Subject: AP1000 COL Response to Request for Additional Information (TR 29)

Westinghouse is submitting a revised response to the NRC request for additional information (RAI) on AP1000 Standard Combined License Technical Report (TR) 29, APP-GW-GLR-044, Nuclear Island Basemat and Foundation. This RAI response is submitted in support of the AP1000 Design Certification Amendment Application (Docket No. 52-006). The information included in the response is generic and is expected to apply to all COL applications referencing the AP1000 Design Certification and the AP1000 Design Certification Amendment Application.

RAI Response Number: RAI-TR29-SRSB-01
Revision: 1

Figure 6-28
DEDVI Break, RCS Pressure

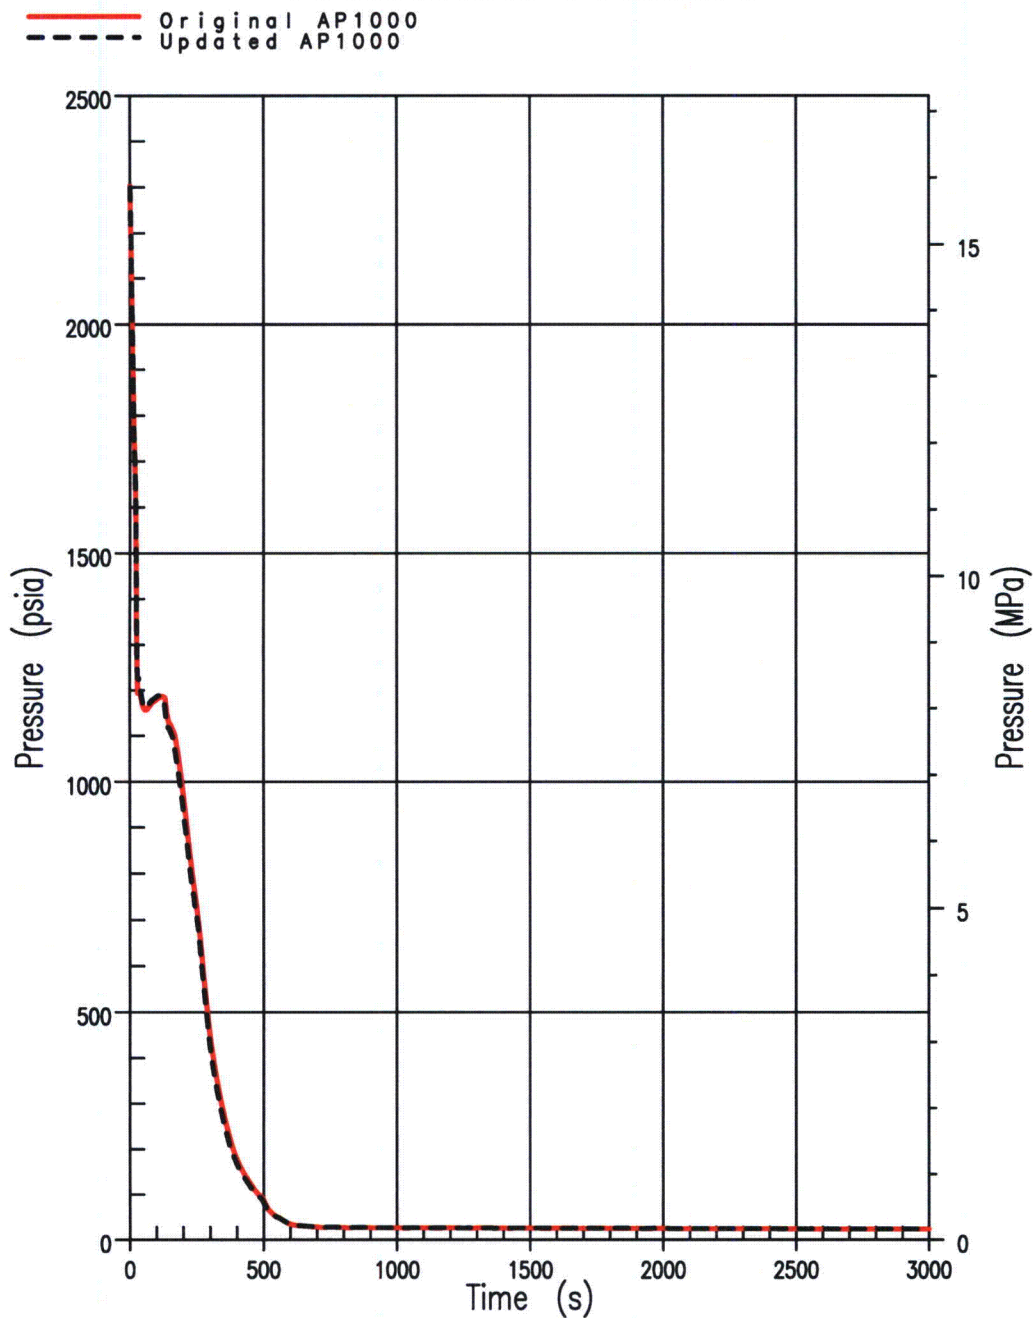
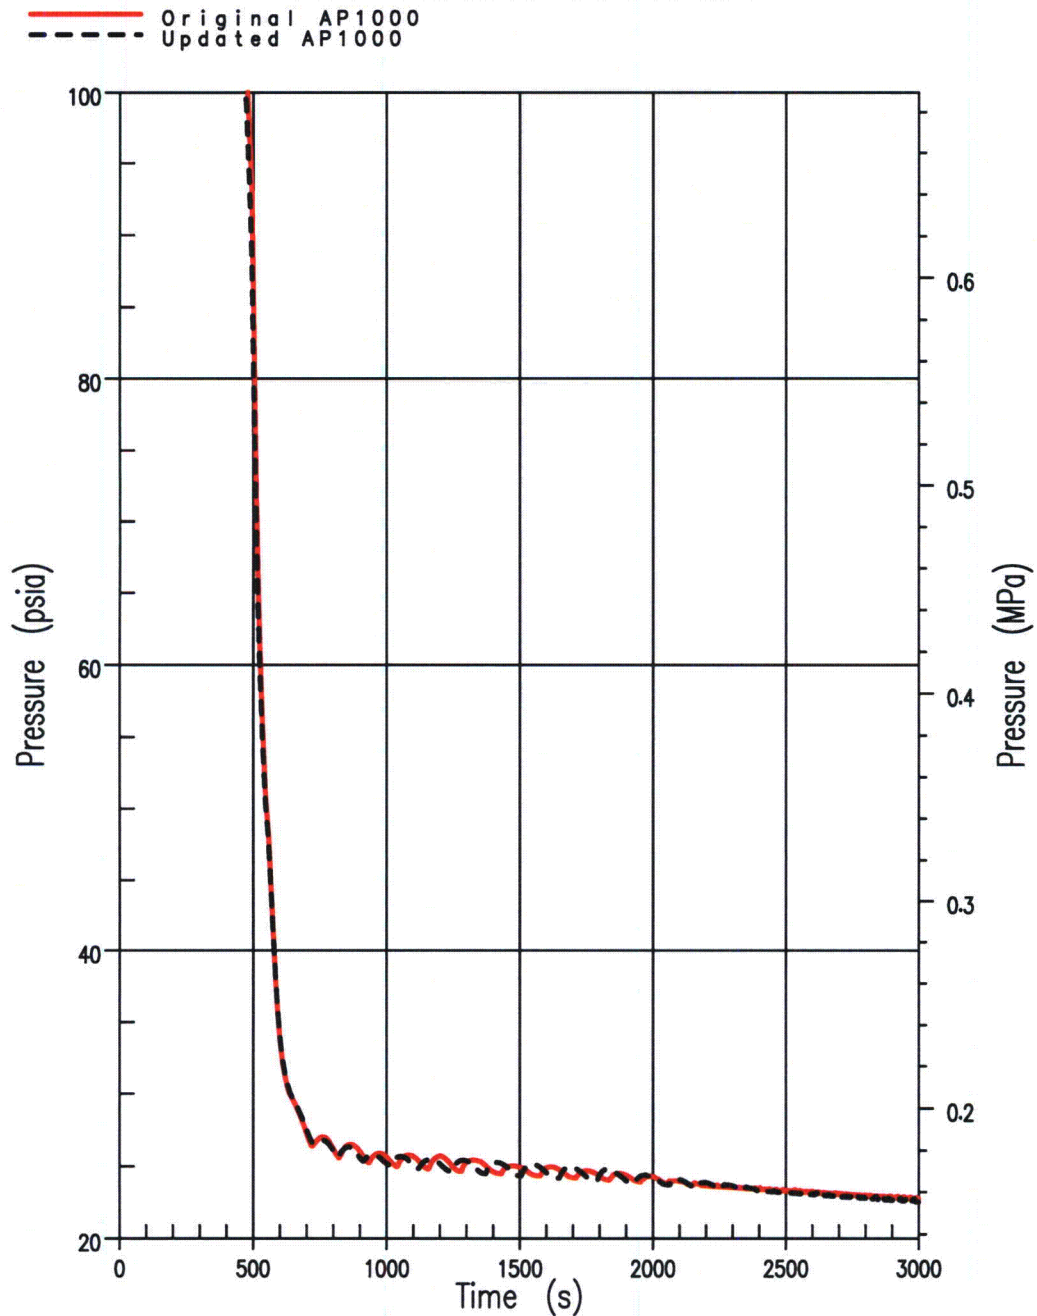
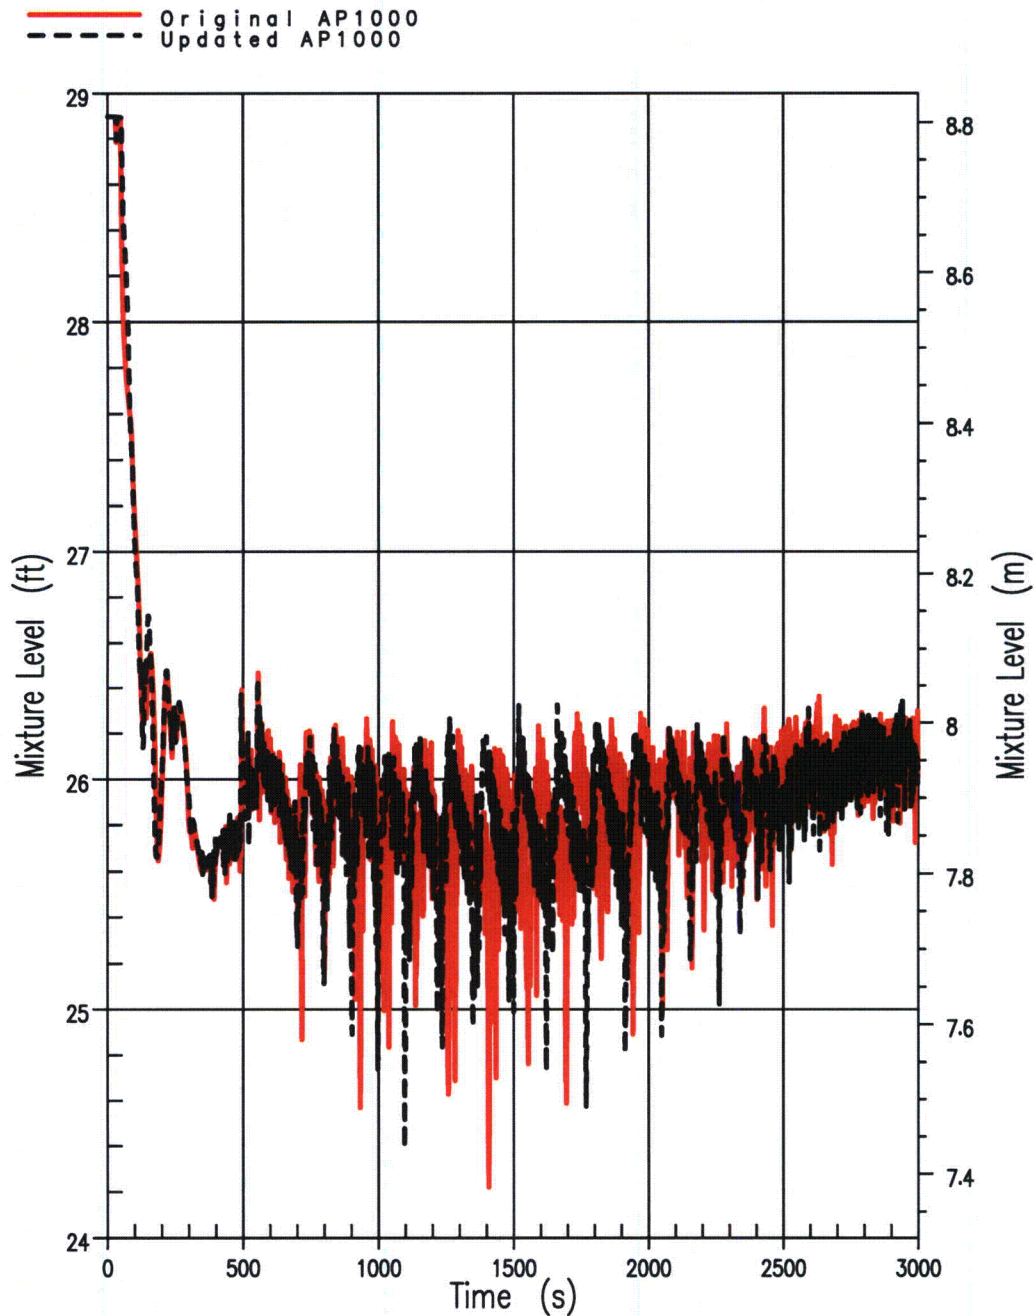
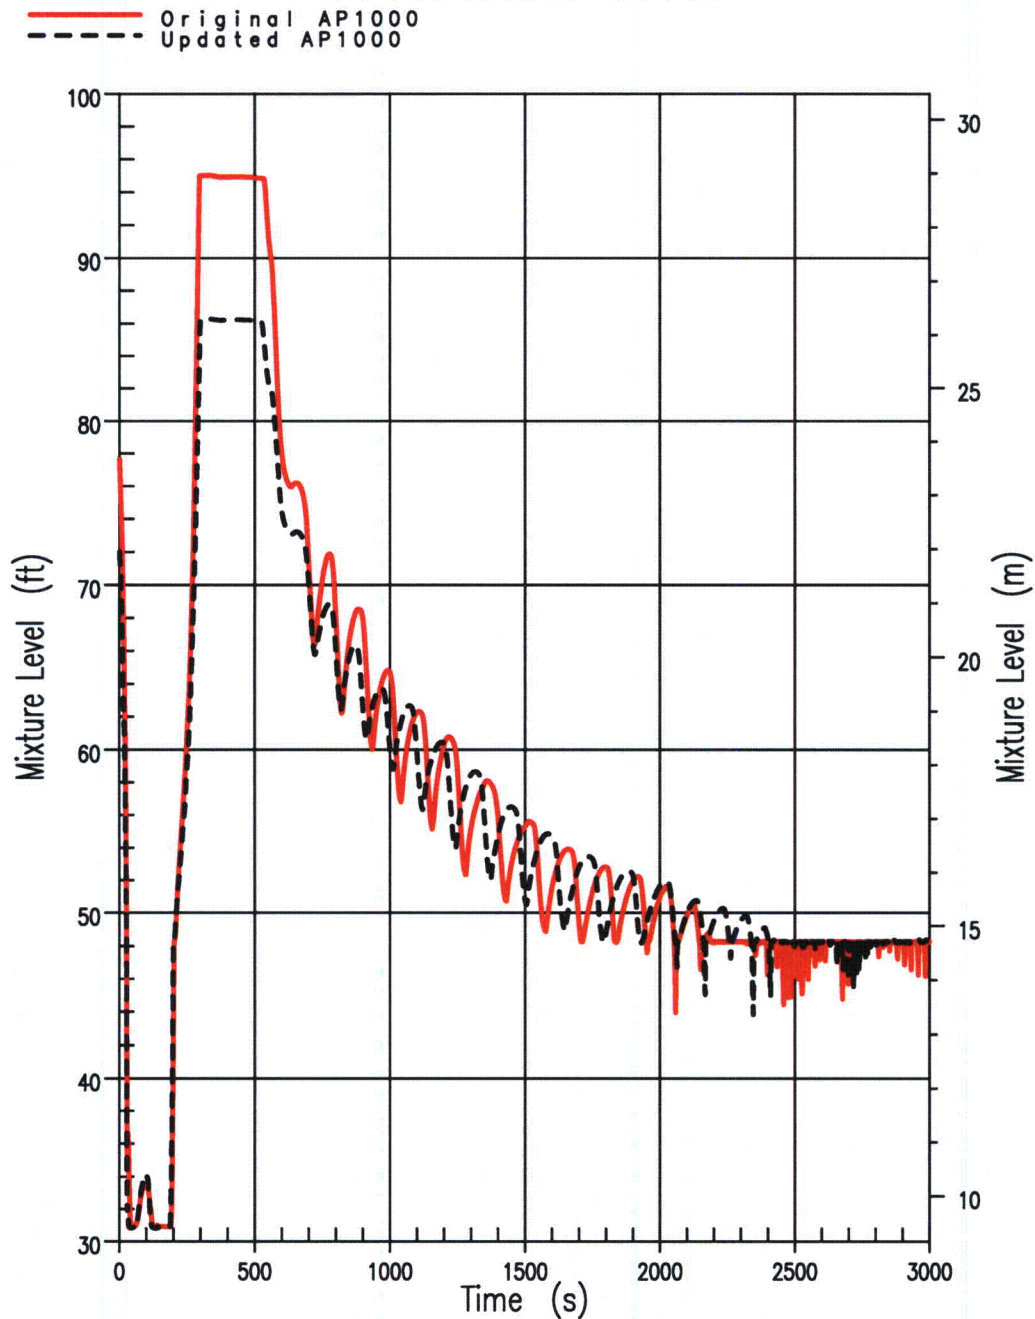
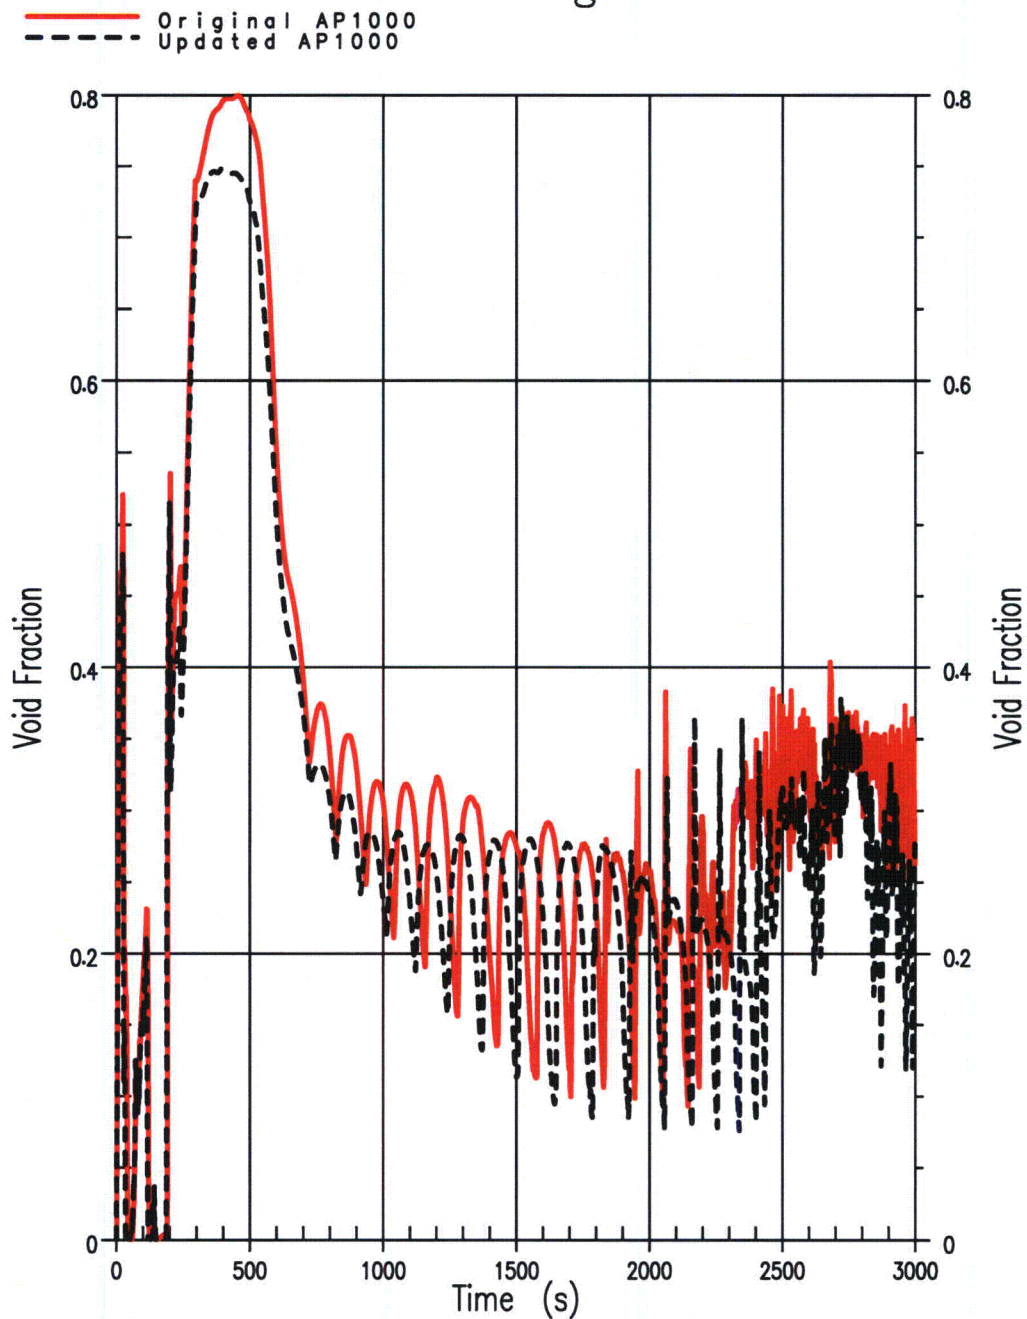
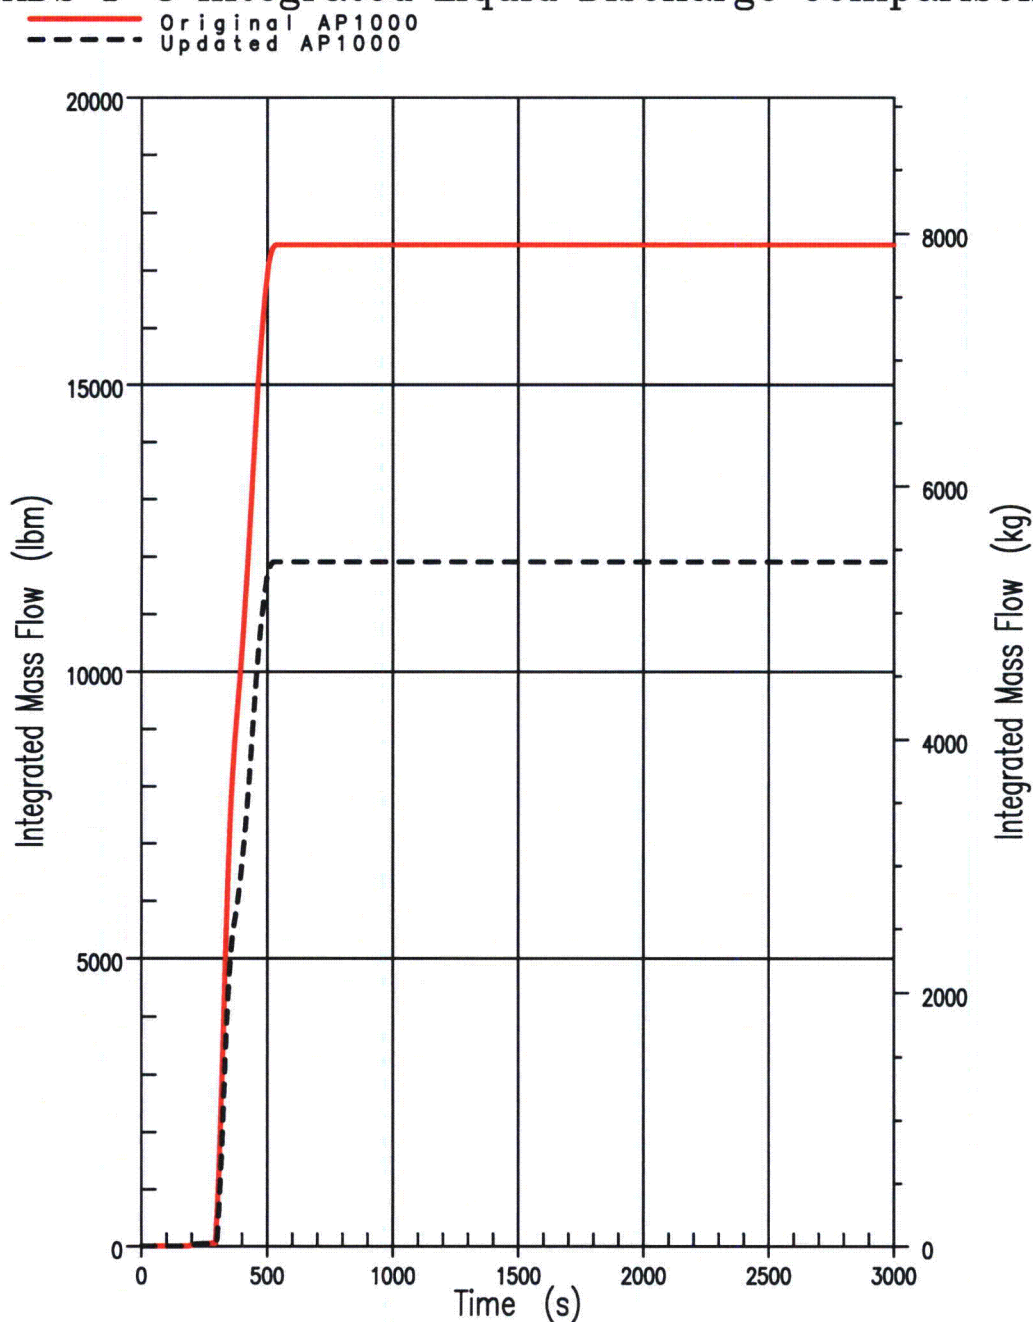
Please provide an evaluation of the impacts of these proposed changes on the analysis results of each of the transients and accidents in DCD Chapter 15. The evaluation should demonstrate either the analysis results of DCD Chapter 15, Revision 15, remain bounding and valid, or the effects of these changes are insignificantly small that the applicable acceptance criteria for these transients and accidents remain complied with.

Table 6-2 and Figures 6-28 through 6-36 present a comparison of the DEDVI line break cases. The results demonstrate the effect of the change in the reactor internals design (including the revised Pressurizer). For the DEDVI line break, the observed changes in response can be attributed primarily to the change in the Pressurizer rather than to the reactor internals changes. The largest observed changes are the decreases in both the Pressurizer Mixture Level (Figure 6-31) and Pressurizer Void Fraction (Figure 6-32). These subsequently reduce the Automatic Depressurization System (ADS) Stage 1-3 liquid discharge (Figure 6-33) and increase the ADS 1-3 vapor discharge (Figure 6-34). The overall effect is slightly larger Reactor Coolant System (RCS) inventory for a majority of the transient simulation period (Figure 6-36), with about the same predicted minimum RCS inventory. No significant changes in the RCS Pressure (Figures 6-28 and 6-29), Core Mixture Level (Figure 6-30), and DVI injection characteristics (Figure 6-35) are observed as a result of the design changes implemented.
